**Economic and Social Council**Distr.: General
27 February 2015

Economic Commission for Europe**Inland Transport Committee****World Forum for Harmonization of Vehicle Regulations****Working Party on Passive Safety****Fifty-seventh session**

Regulation No. 44 (Child restraint systems)**Proposal for Supplement 10 to the 04 series of amendments to Regulation No. 44 (Child restraint systems)****Submitted by the expert from Spain***

Figure 1
Procedure type 1

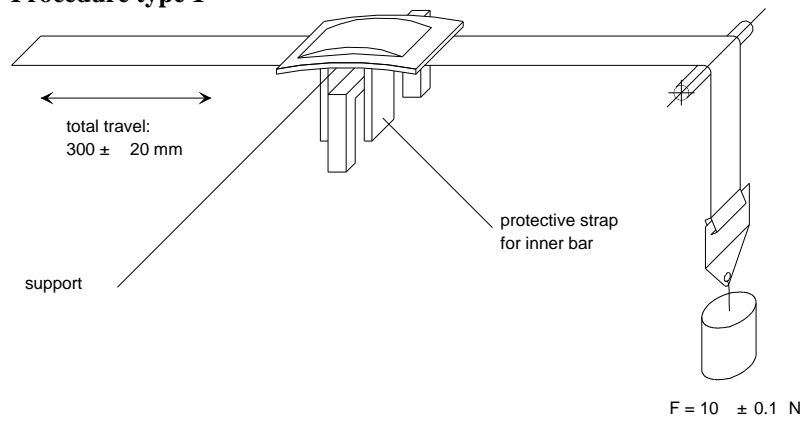
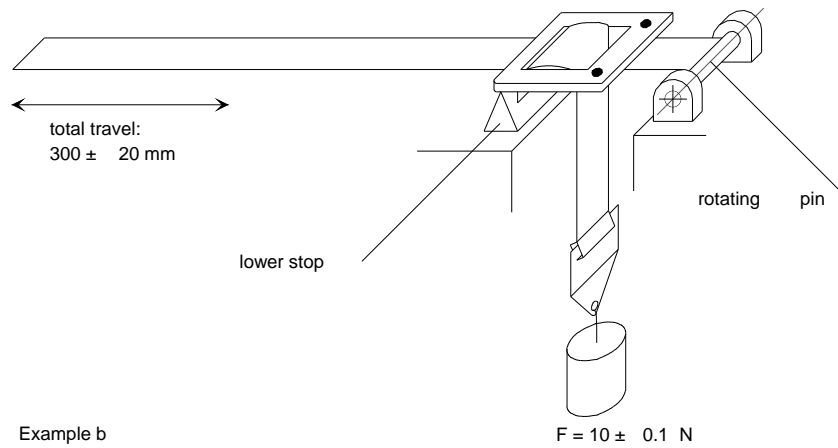
8.2.5.2.6.3.1. Type 1 procedure: for cases where the strap slides through the quick adjusting device. **Apply a load of 10 N, if necessary the load may be increased by 10 N steps so as to permit correct sliding, but limited to a maximum of 60 N. This** ~~The 10 N~~ load shall be vertically and permanently applied on ~~one~~ of the straps. ~~The other~~ **part of the** strap set horizontally **shall pass through the quick adjuster it is fitted to and** shall be attached to a device, giving the webbing a back and forth motion. The **quick** adjusting device shall be so placed that the horizontal strap of the webbing remains under tension (see Annex 5, Figure 1). **Activate the quick adjuster while pulling the straps in the direction to slacken the harness and deactivate it while pulling the straps in the direction to tighten the harness.**

Remark. $F = 10 \pm 0.1$ N, can be increased up to $F = 60 \pm 0.5$ N

7. Annex 5: Drawing modified to be consistent with new paragraphs 8.2.5.2.6. to 8.2.5.2.6.3.2.

Figure 2
Procedure type 2
Following two examples of test set up;
Example 1

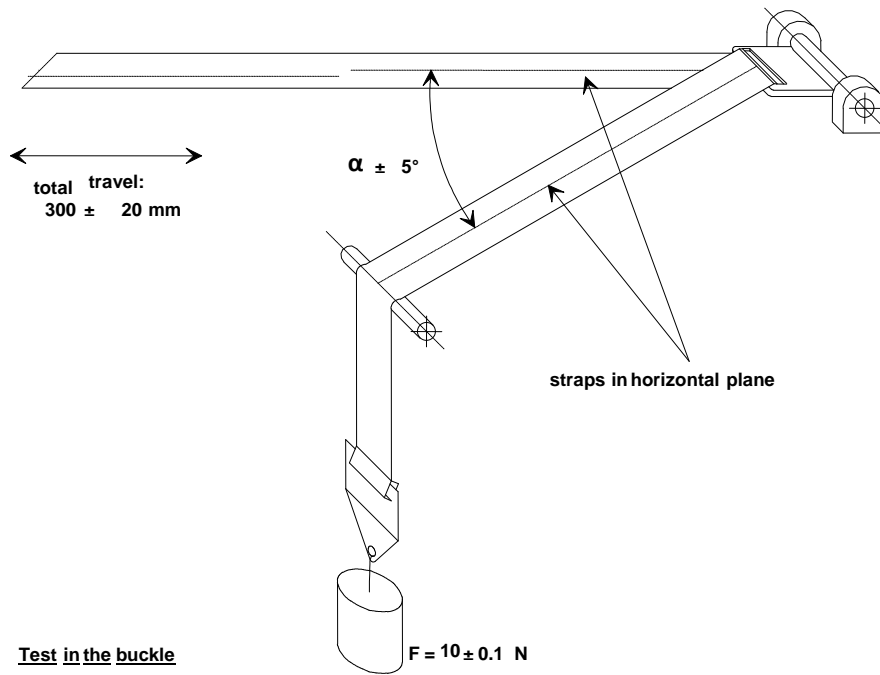
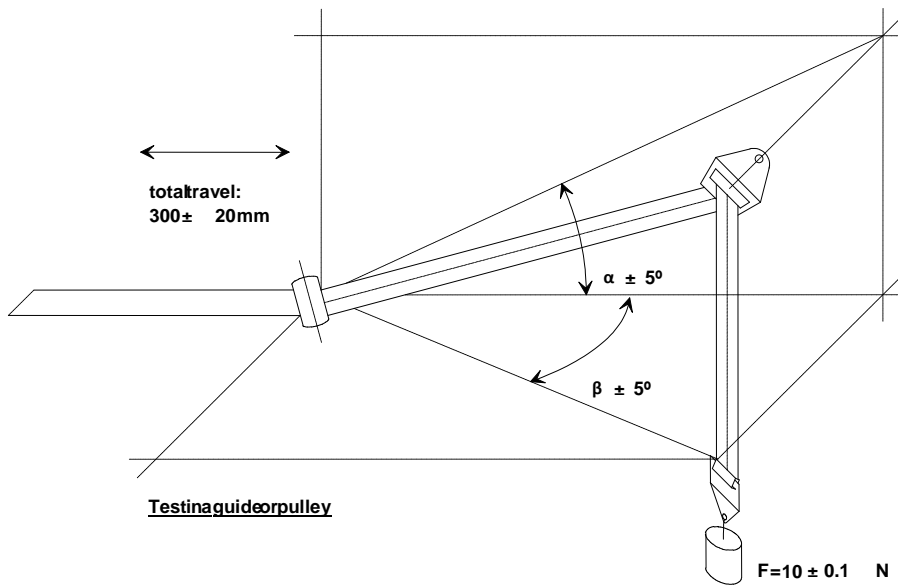
8.2.5.2.6.3.2. Type 2 procedure: for cases where the strap changes direction in passing through a rigid part. During this test, ~~the angles of both webbing straps shall pass through the rigid part it is intended for and the test set up shall reproduce the angles as in the real installation (in three dimensions), see be as shown in Annex 5, Figure 2 for examples.~~ The **≤ 10 N** load shall be permanently applied. For cases where the strap changes direction more than once in passing through a rigid part, the load of **≤ 10 N** may be increased **by 10 N steps** so as to **permit correct sliding and** achieve the prescribed 300 mm of strap movement through that rigid part."

Where α and β reproduce the angles as in the real installation (in three dimensions).

Figure 1
Examples of completely recessed support leg

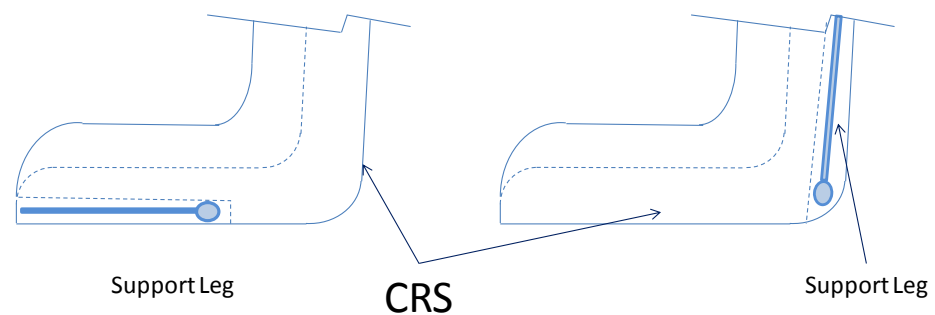
- "7.1.4.1.10.1.2. Without the anti-rotation device in use. **If the anti-rotation device is a support leg and it can be completely recessed within the base or the shell of the CRS, the test is conducted with the device in its stowed position or with the leg removed respectively. If it cannot be completely recessed within the base, the test is performed with the device deployed in its shortest length with the trolley floor pan in its lowest position.**
- This requirement does not apply when a permanent and non-adjustable support leg is used as an anti-rotation device."

Completely recessed means that with the leg in the stowed position, no part of the leg protrudes beyond the surface of the base or shell, such that it has no effect on the position of the CRS on the test bench. See the following figures for clarification examples.
